# **BGA TECHNICAL COMMITTEE**

# TECHNICAL NEWSHEET 7/8/96

PART 1	Airworthiness "AGGRO"
1.1.	OLYMPIA 460 Series. The attached Tech.Note circulated to owners / Technical / Safety Officers, is self explanatory. The AAIB investigation will take some time.

ASV 20 Technical Note No. 31

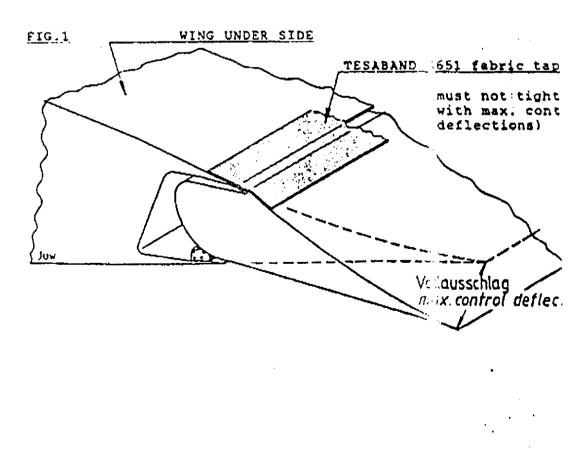
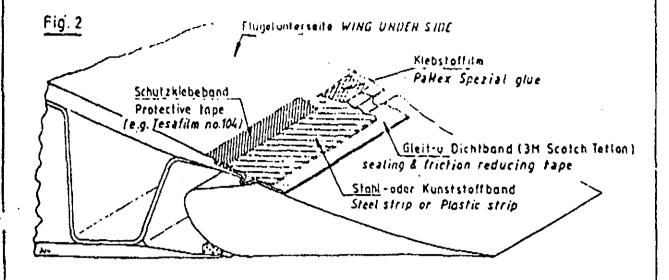
Recently two ASV 20s had aileron flutter in flap position 1 a a speed of about above 200 to 210 km/h. The raid ASY 20s wer improperly equipped with an elastic plastic tape to seal th gap between wing and flaps/ ailerons on the inder sides; the used strips of tape which were insufficiently curved, an above all the teflon, strip which has to lie undermeath fo sealing the gaps, was missing. Owing to this, air exchange bet ween wing upper side and under side is possible which causes depending on the control surfaces' deflection - periodical sep aration of airflow and this unusual kind of aileron flutte:
These latest findings also account for earlier flutter inci dents which occurred mainly in countries with warm climat (see TN no.12). In those cases the gliders used insufficientl stiff plastic tape (partly even without fabric stiffening which softened under high temperatures and therefore coul crease periodically inwards and outwards thus causing varying airflow separation on the control surfaces under side an thereby leading to aileron vibrations.

- 1. Prior to the next take-off it must be chicked whether th control surface gap on the wing under side is equippe with a sealing, i.e. either
  - fabric-tap 1.1 with the factory-standard, plastic-treated TESABAND 4651, white, 38 mm wide (see Fig.1); in that cas the plastic coat on the fabric must not be damaged.  $d_{\perp}^{\pm}$ lored or even weather-worn; the tape must not tighten at full control surfaces deflections.
  - 1.2 with the pre-curved steel strip (0.07 on thick) or th pre-curved plastic tape (MYLAR O, 25 mm thick) respective ly: in that case check that both require absolutely Teflon sealing tape underneath for the purpose of sealing the gap and reducing the friction (see ):g. 2).

5.4 m Teflon tape, self-adhesive, 30 ms wide.

2 x 2.7 m metal tape, 33 mm wide, pre-curved by 8 mm Fig. 3) and Pattex Spezial glue; or

$2 \times 2.7$  m MYLAR tape, 37.5 mm wide, pre-surved by min. coated with a glue fulm of 14 mm width (see Fig.4).

2 x 4.5 m metal tape, 33 mm wide, pre-curved by 5 mm (see Fig.3) and Pattex Spezial glue; or

2 x 4.5 m HYLAR tape, 37.5 mm wide, pre-curved by min. 6 mm, coated with a glue film of 14 mm width (see Fig.4).

Ruddel (2012) PERASUS ( ASW19 / ASW 20

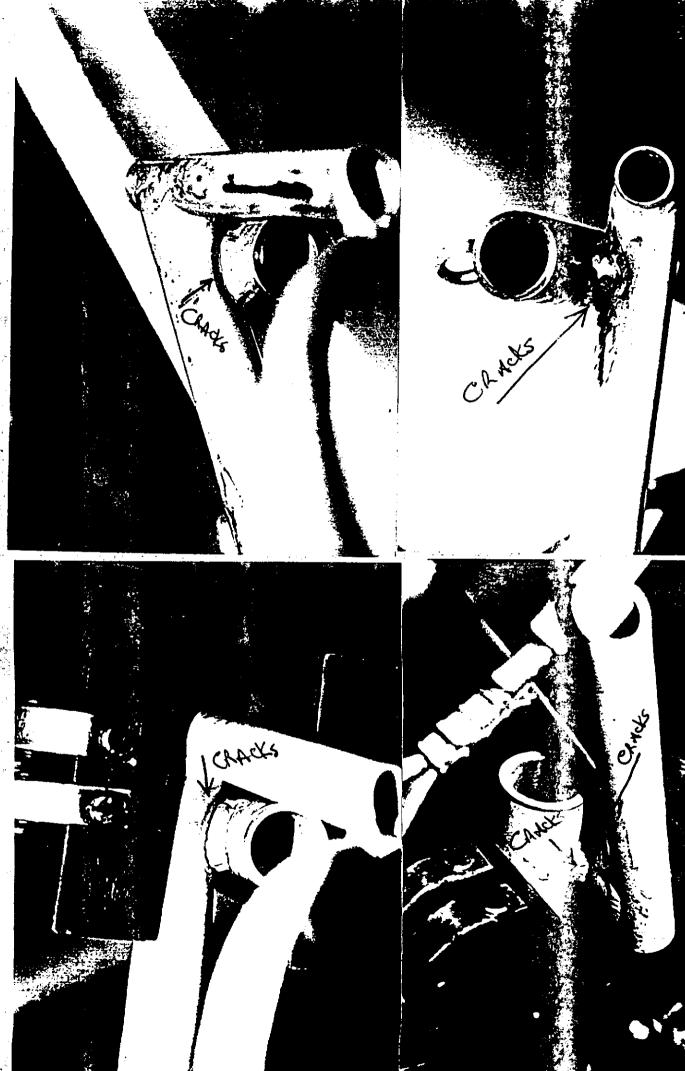
1.4.	Bocian Trim Tab becomes disconnected causing elevator oscillation. Check for security at the tab. (Highland G.C.)
1.5.	CRACKS in Rudder Pedals. (Pegasus/ASW19/ASW20) Photos illustrated the problem. (from Richard Kimberley).
